I. INTRODUCTION

In accordance with the California Environmental Quality Act (CEQA) Guidelines Sections 15088, 15089, and 15132, the City of Ridgecrest has prepared the Final Environmental Impact Report (EIR) for the proposed Ridgecrest Wal-Mart and Retail Center Project. Section 15132 provides that the Final EIR shall consist of: the Draft EIR or a Revised Draft EIR; comments, either in verbatim or in summary received in the review process; a list of persons commenting; the responses of the Lead Agency to the comments received; and any other information added by the Lead Agency, which can include minor corrections or modifications.

II. RESPONSE TO COMMENTS

P-10

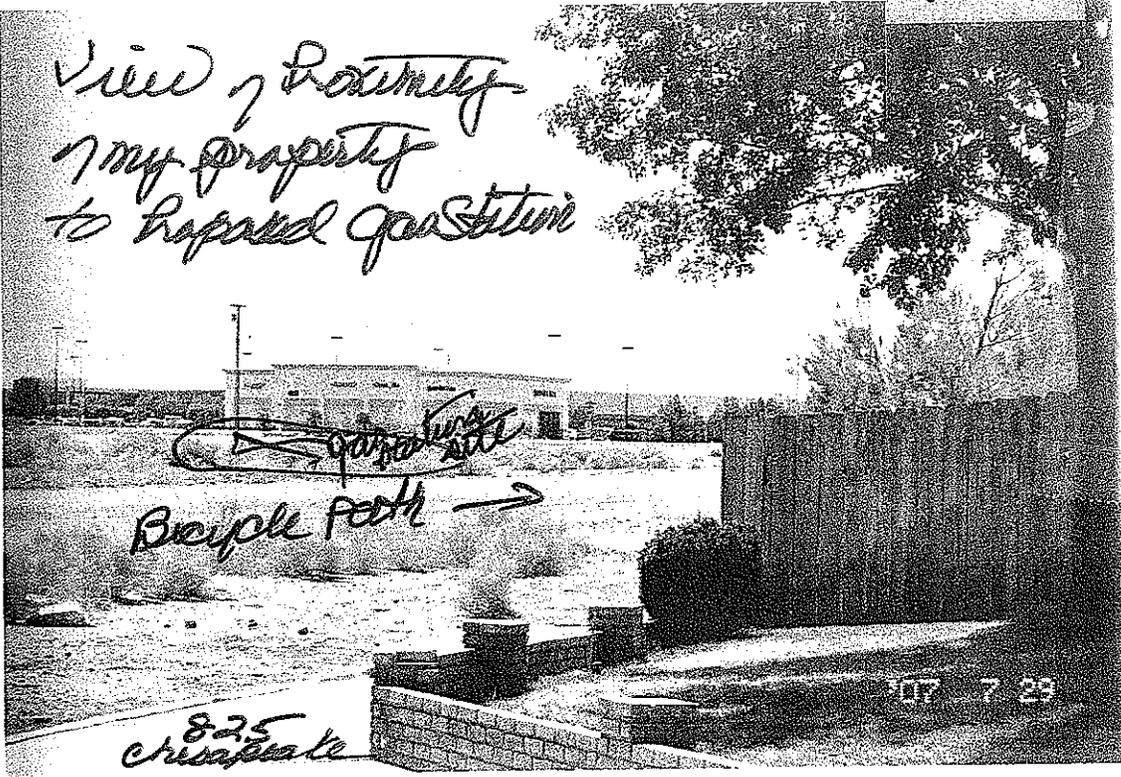
The 18 pump gas station which is proposed is across the street from my property and is of special concern (see P 10 – 12 and A – 16). A gas station would not only add noise but also gas and diesel fumes which would pollute the environments in proximity to the project. Dust from construction and fumes from a gas station would undoubtedly affect the health of children and adults locally who are at-risk for pulmonary problems. I have a considerable medical history of pulmonary problems.

Proposed site of gas station

P-12

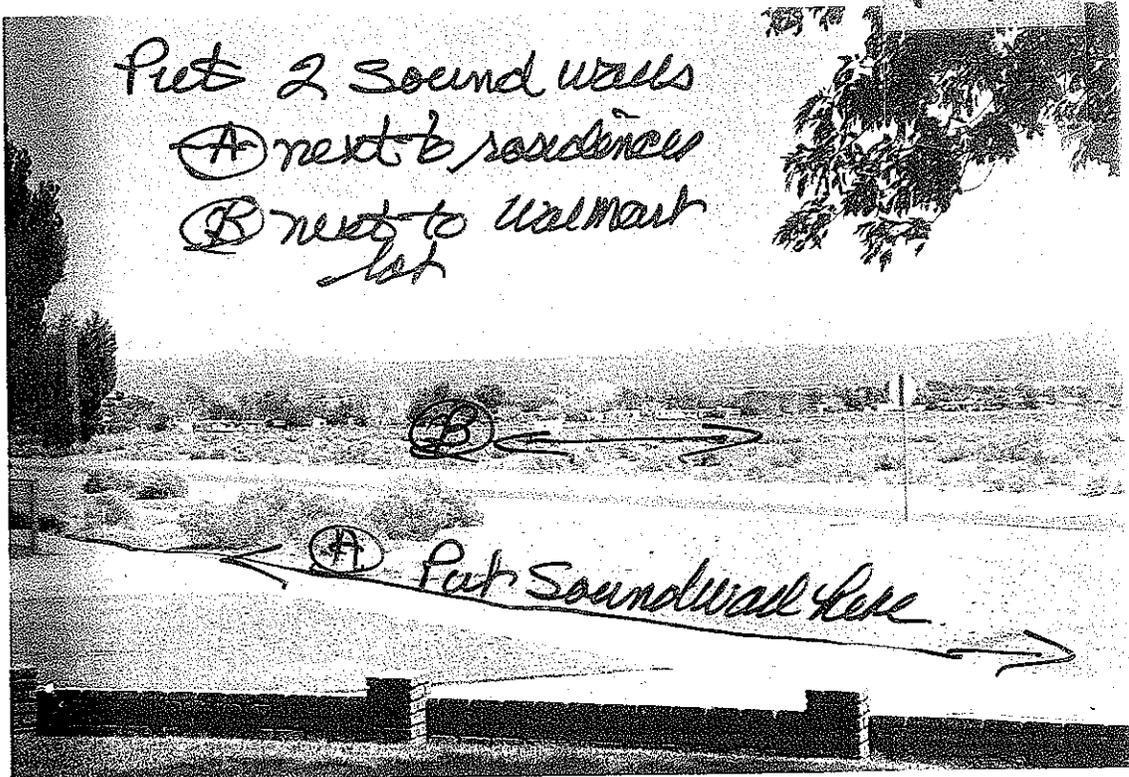
Proposed area of 18 pump gas station

Put 2 sound walls
Ⓐ next to residences
Ⓑ next to Walmart
lot

The comment states the need for the construction of two cinder brick soundproofing walls. However, as discussed above, daytime operational noise impacts associated with the proposed project would be less than significant and therefore no mitigation is required. Mitigation Measures H-2 and H-3 are provided to reduce potentially significant nighttime operational noise impacts to less than significant levels. In order for an effective noise barrier design, a sound wall would need to be constructed along the length of the entire project site. Because daytime operational noise impacts would be less than significant and because nighttime operational noise impacts can be mitigated with implementation of Mitigation Measures H-2 and H-3, a sound wall would not be a feasible, cost effective noise reducing measure, and could raise additional aesthetic impacts, and therefore it is not required.

P-14

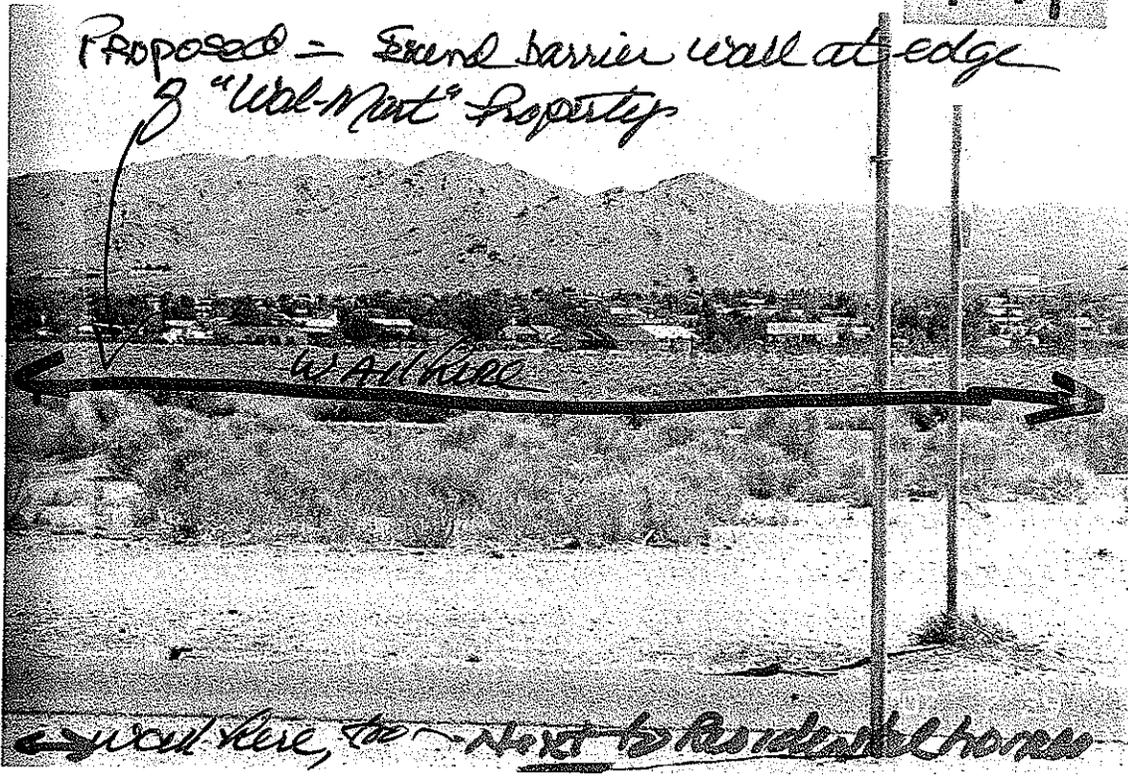
Proposed = Sound barrier wall at edge
of "Wal-Mart" Property

Bowman/China Lake Roundabout Size Study

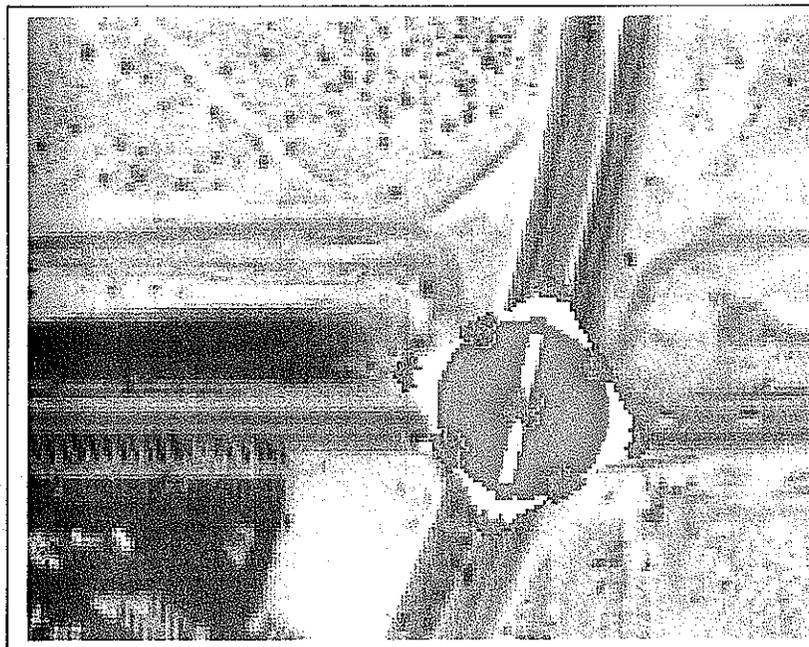
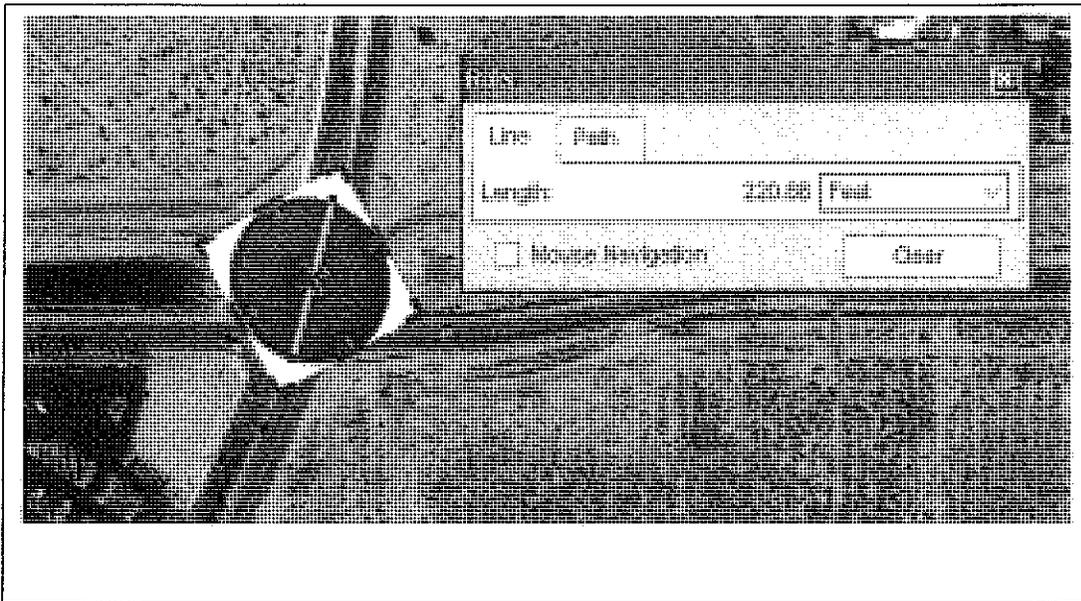
150 Ft Circle Urban Single Lane
Capacity (20,000 Cars per day) @ 20 Miles per Hour

220 Ft Circle Urban *DOUBLE* Lane
Capacity (40-50,000 Cars per day @ 25 Miles per hour)

Conclusion: High Capacity Urban Roundabout with Two Lanes Entering from Four Directions appears supportable without impacting Northern Quadrant Land Owners

- Bridge and Underpass Locations

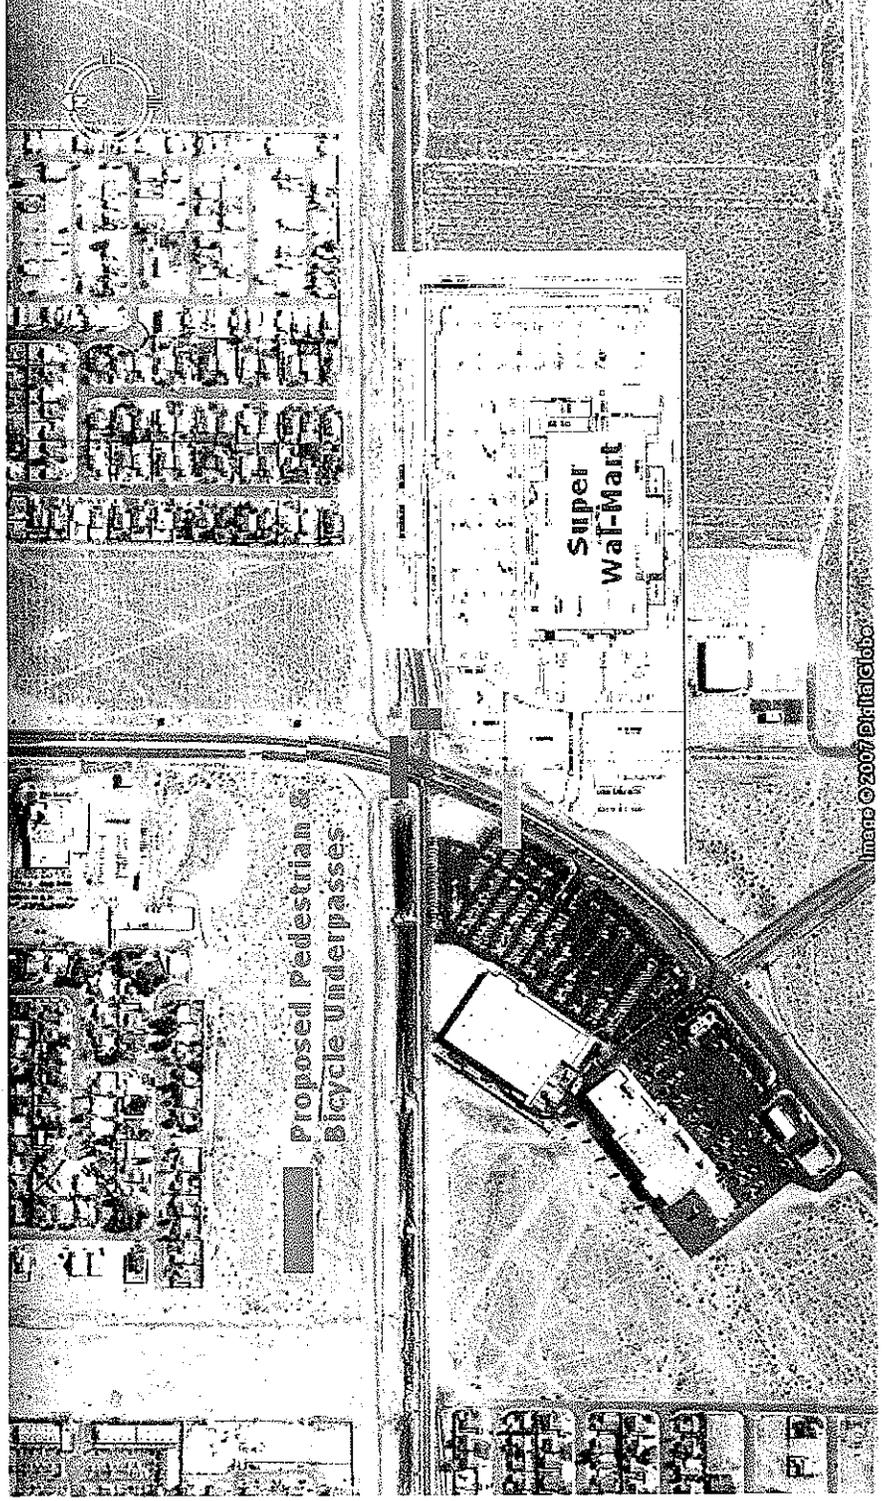
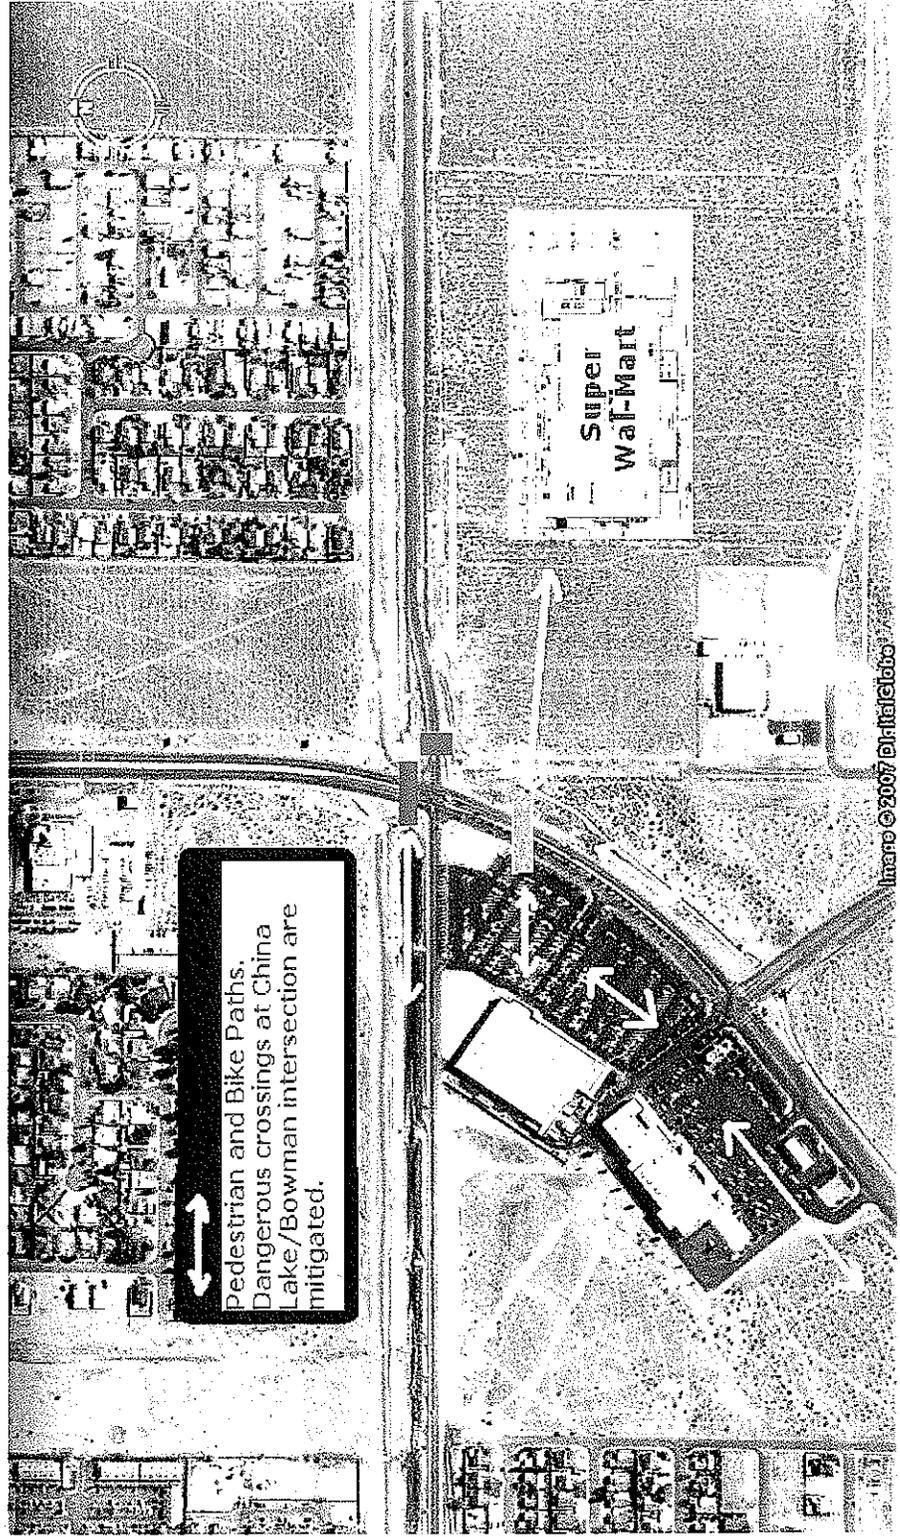
- Pedestrian/Bicycle Access Bridge and Underpasses
 - A combination of both an access bridge over China Lake Blvd and underpasses beneath Bowman and China Lake Blvd's would optimize the convenience and safety of non-vehicular movement between and around the two centers.
